REGISTRY OF RADIOACTIVE SEALED SOURCES AND DEVICES  
SAFETY EVALUATION OF DEVICE

NO: NR-182-D-101-S

DEVICE TYPE: Gamma Gauging Device

MODEL: BEC-104

Figure -1

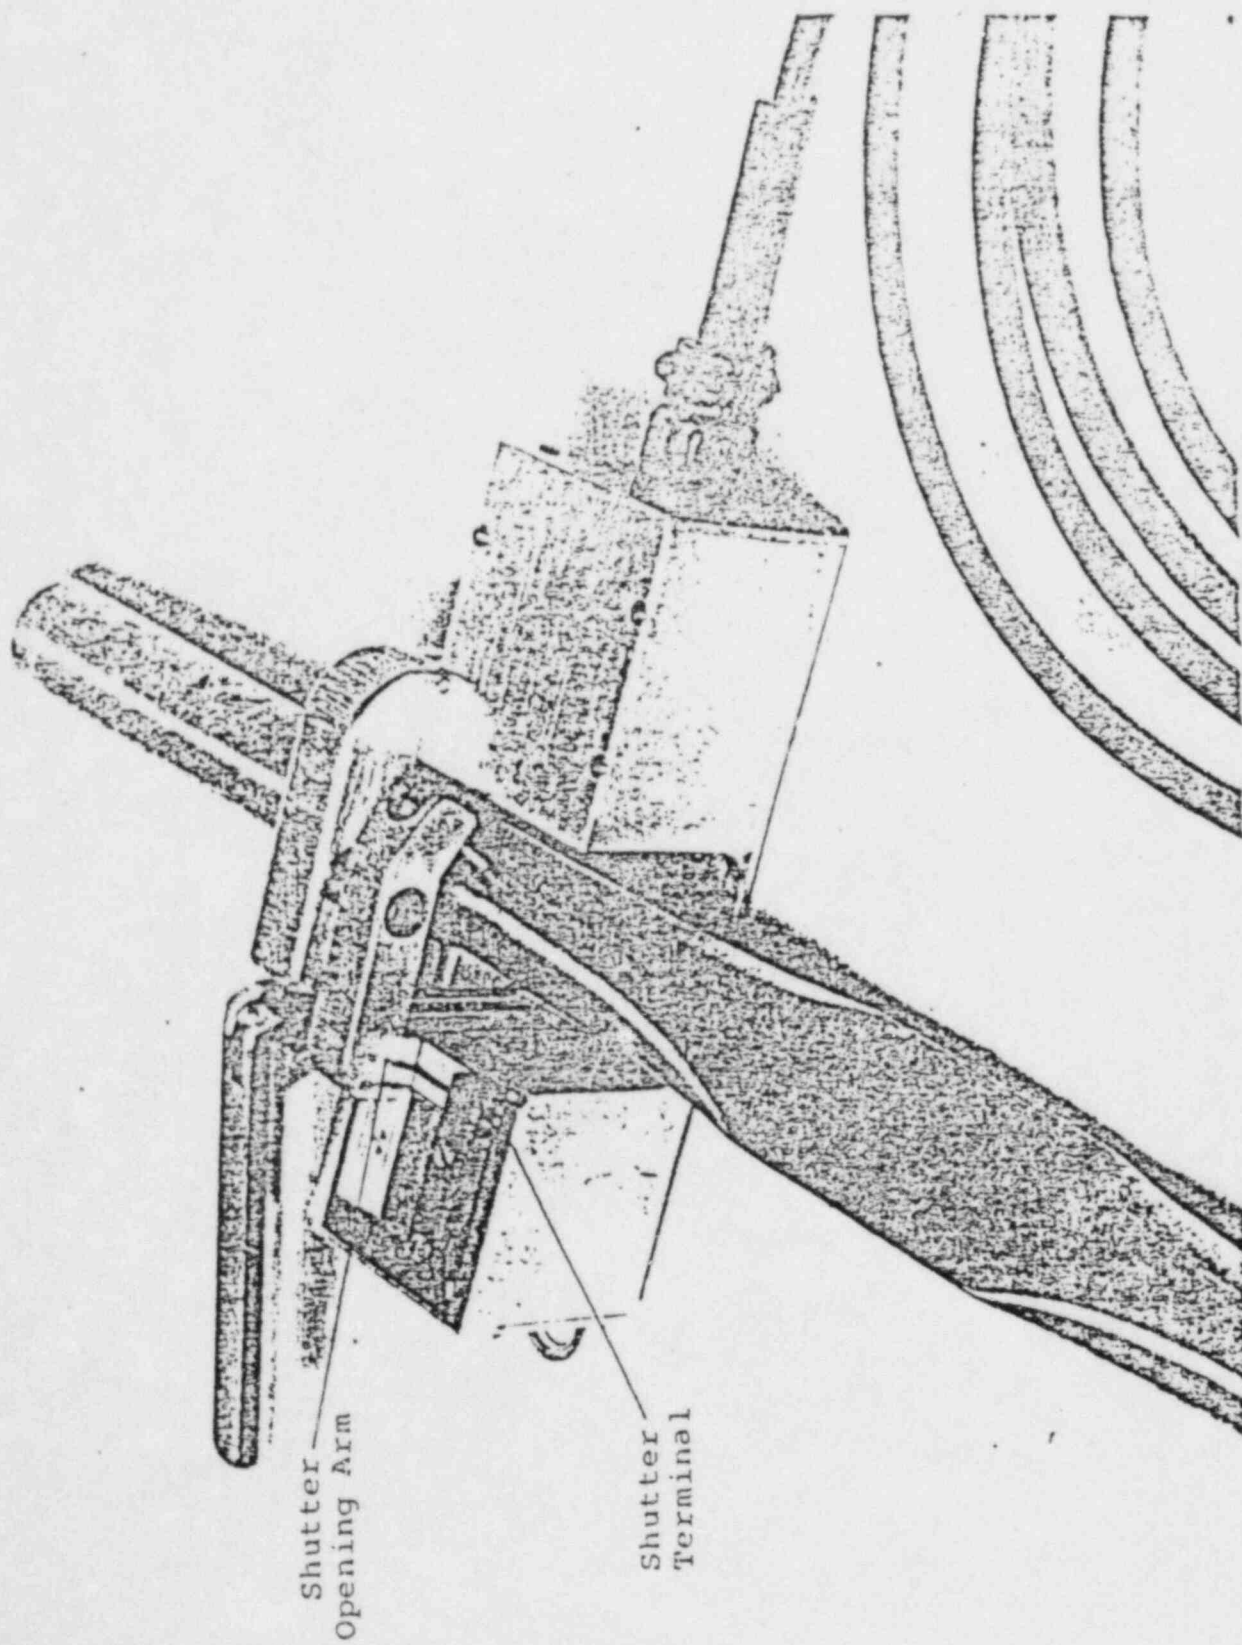
The key features of the device are shown in the assembly sketch (B032, Enclosure 1). The radioactive source capsule (Item 7) is retained in the source holder (Item 6) by the brass screw (Item 8). The loaded holder as an assembly is threaded into the main brass housing (Item 10). A wire and lead crimp seal is installed thru item (6, 8, and 9) to prevent removal of the source capsule once installed in the main housing.

A spring loaded shutter (Item 4) is installed in the main housing as shown. The shutter is constructed of 3/8" thick brass and is held captive in the main housing by the cover plate (Item 1) and the base plate (Item 11). When the shutter is fully depressed (open condition) the radiation beam emerges from the aperture (Item 4a). This aperture may be circular or rectangular and will have an open area not to exceed 0.035 square inches. A second hole (Item 4b) is bored thru the upper tab in the shutter for purposes of locking the shutter closed. This tab extends through the slot in the cover plate when the shutter is closed.

An electrical contact (Item 3) is installed in the cover plate as shown. When the shutter is fully closed, the circuit for the shutter indicator lights is completed.

A minimum of 3/8" of brass shields the source when the shutter is closed. Surface radiation levels are barely detectable over background with the shutter closed and are well below 0.5 mrem/hr.
